SUBMITTER No.	1840	ISSUE REFERENCE:	9109
SUBMITTER TYPE	Council	TOR CATEGORY	Social / Waste / Land
NAME	Barcaldine Regional Council	RELEVANT EIS SECTION	1.1.4

SUBMITTER No.	1840	ISSUE REFERENCE:	12021
SUBMITTER TYPE	Council	TOR CATEGORY	Air Quality / Land
NAME	Barcaldine Regional Council	RELEVANT EIS SECTION	Air Quality, Vol 2 Chapter 10

SUBMITTER No.	419	ISSUE REFERENCE:	4001
SUBMITTER TYPE	Government	TOR CATEGORY	Land (Land Contamination)
NAME	DERM	RELEVANT EIS SECTION	Volume 2, Mine – Section 3.4.6.2 (p131)

Figure 18. Rail Infrastructure Crossing (Sheet 1 of 5)

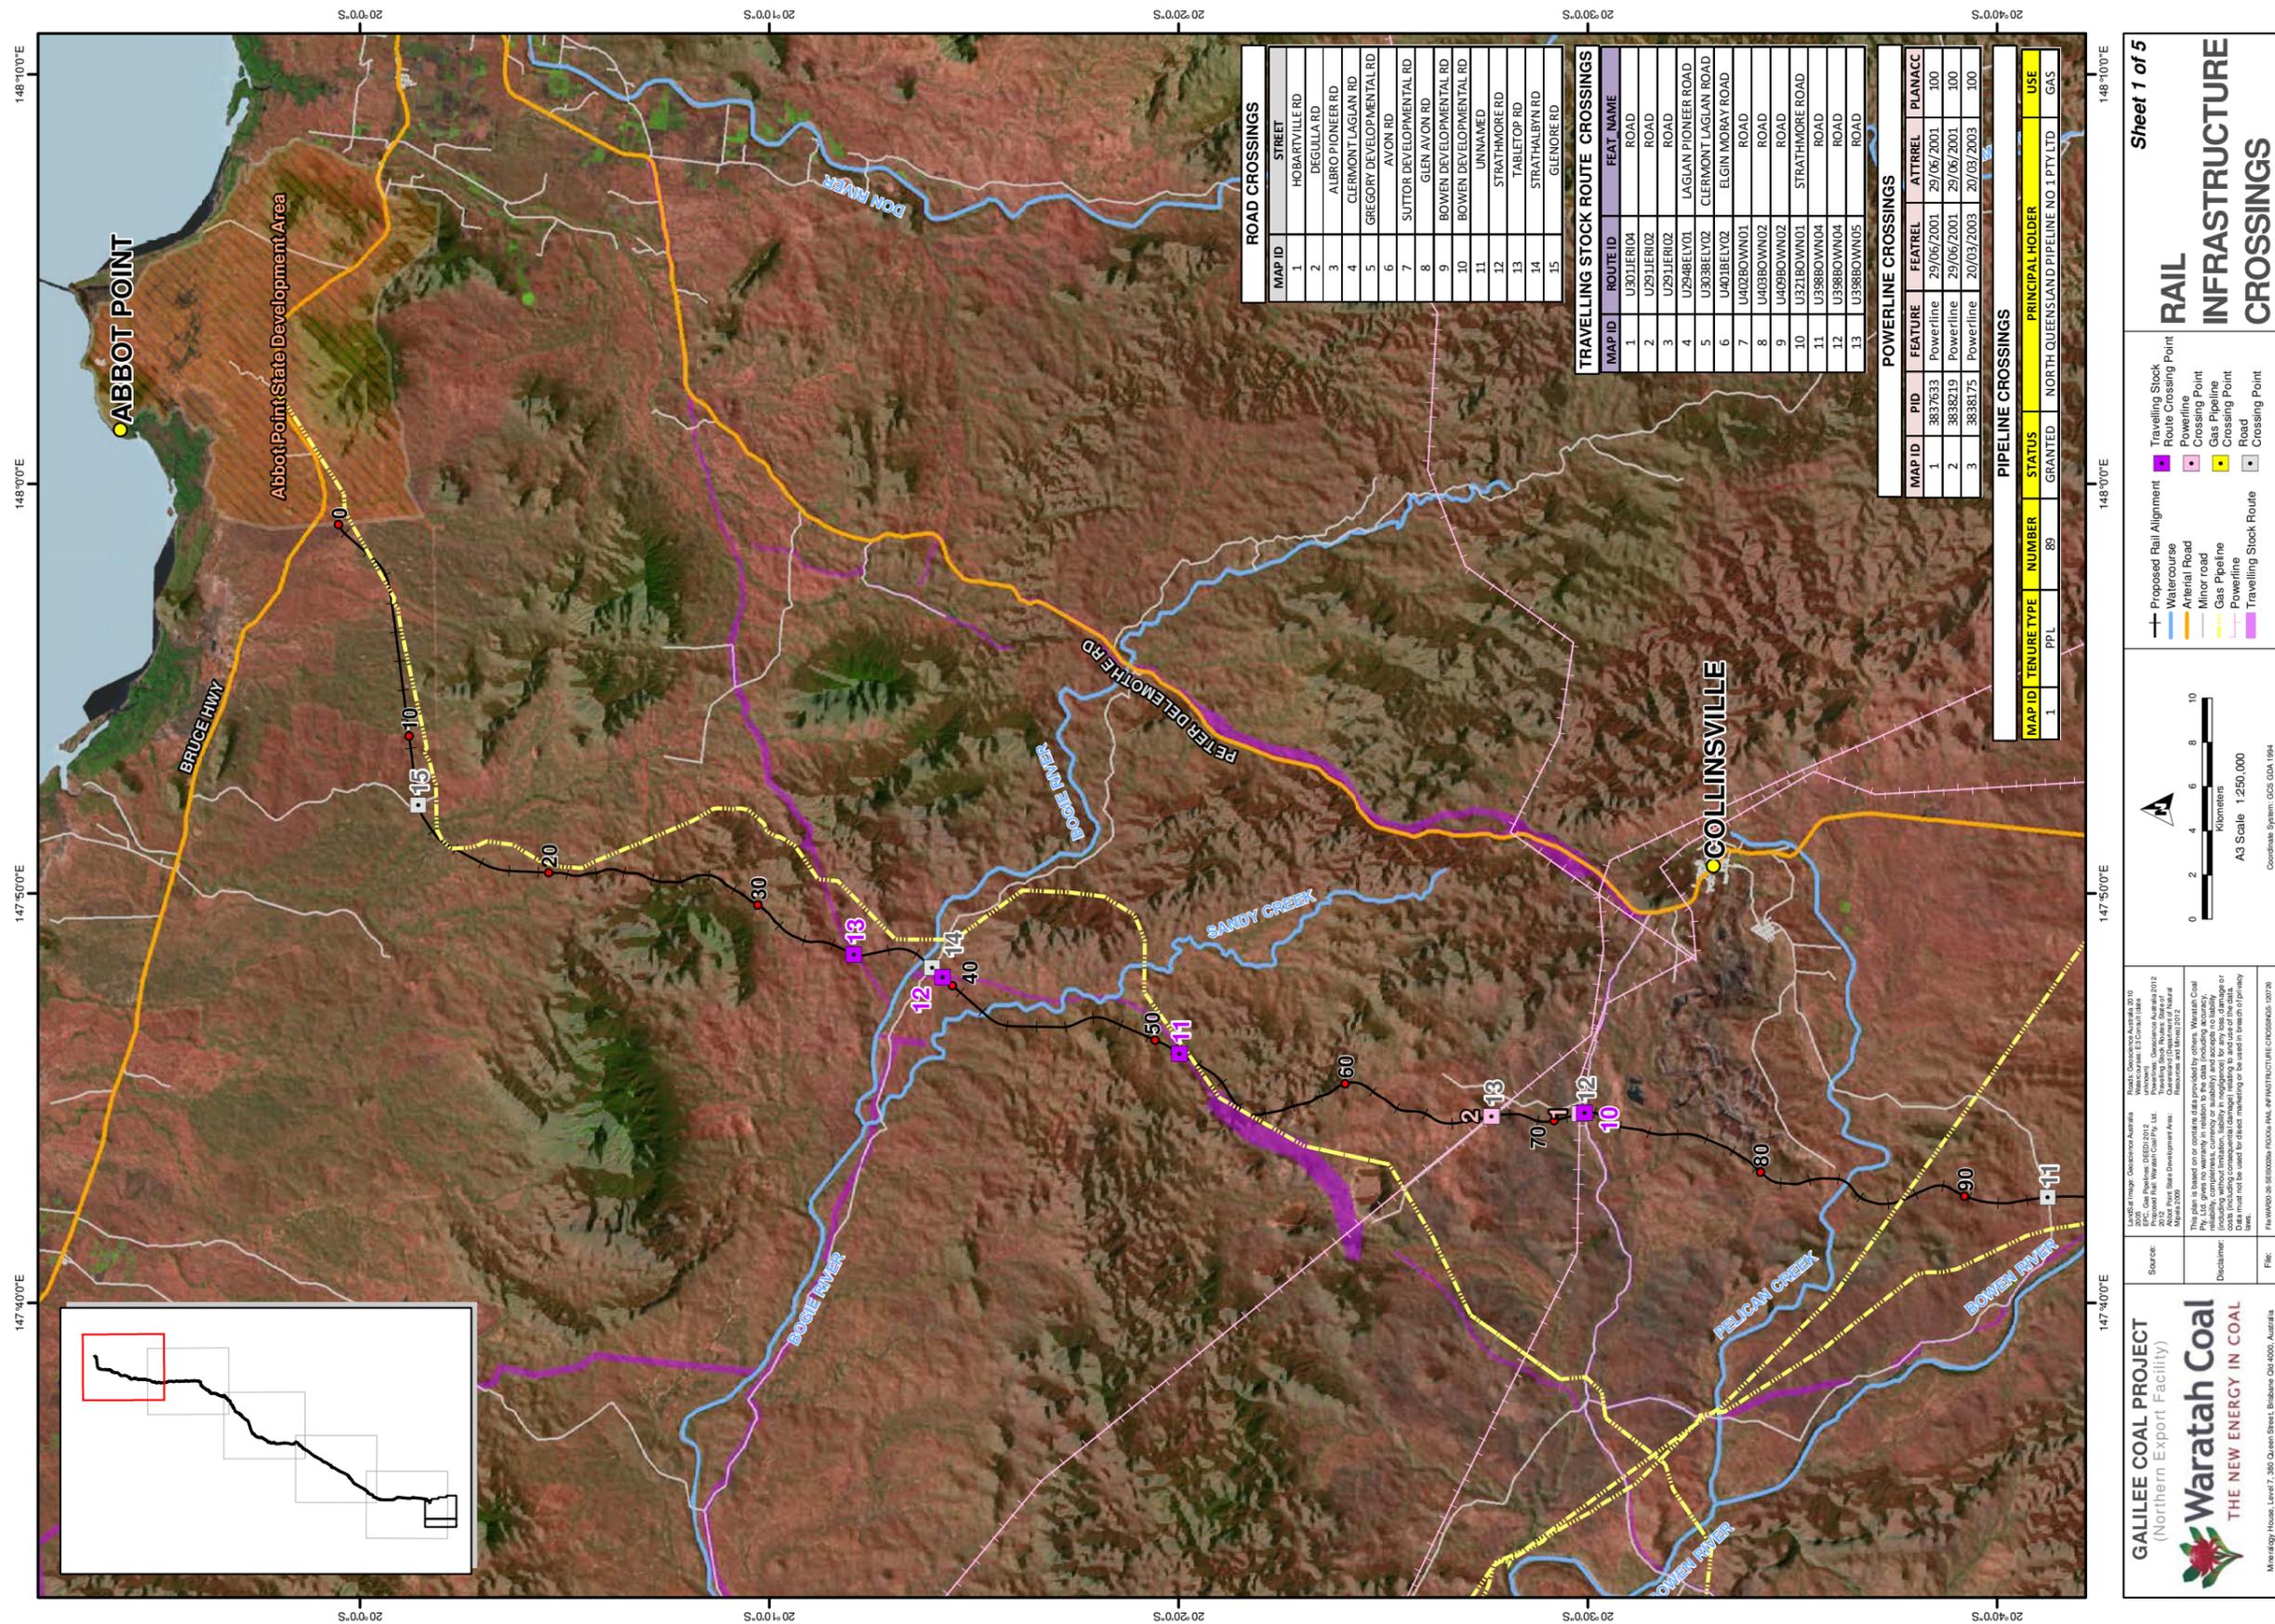
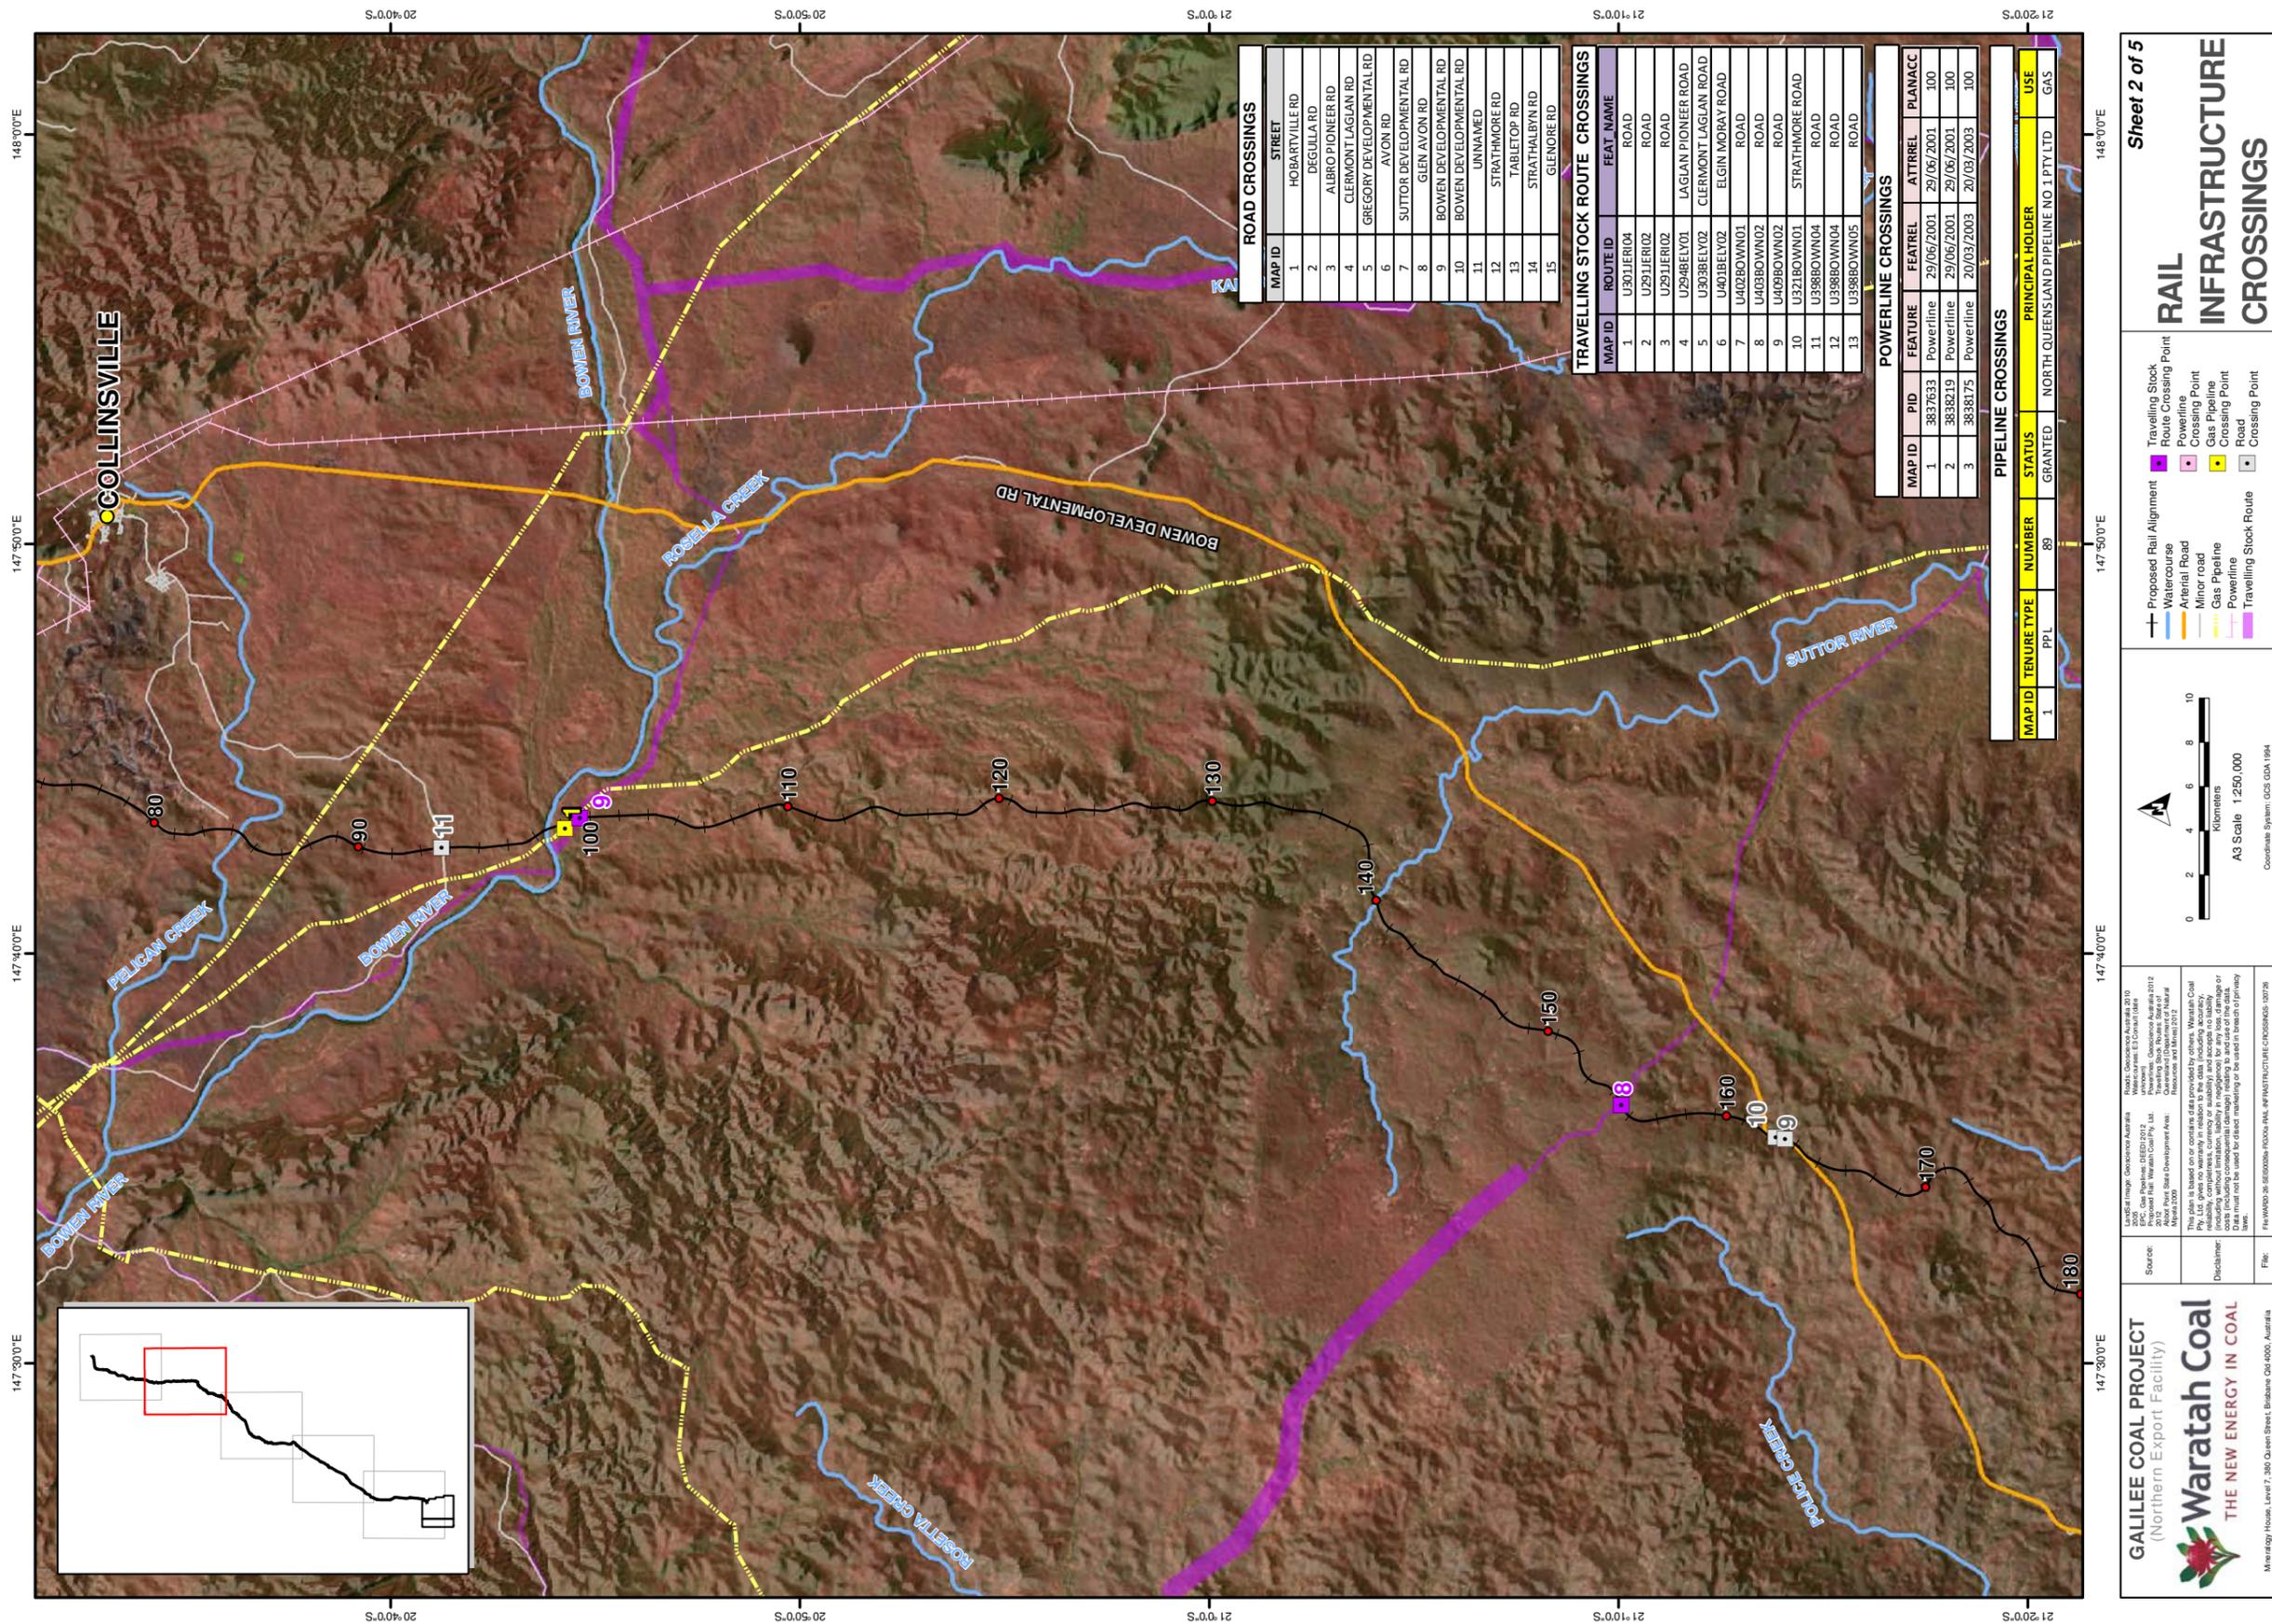
The EIS should detail how travelling stock can be moved from one side of the rail corridor to the other and thereby maintain the utility and connectivity of the stock route network.

The stock routes within the project region have been identified and are shown Figure 18. Where the Waratah Coal rail line traverses across an existing stock route, an undertrack crossing for the stock will be provided that limits the amount of ‘tunnel effect’ to a similar standard to those recently constructed for new rail projects within central Queensland and provides a safe and effective path for the stock and stockmen.

Where the rail alignment cuts across the same stock route in several places within a relatively short distance, there may be an opportunity to realign the stock route along one side of the rail only, to provide a shorter and more effective stock route.
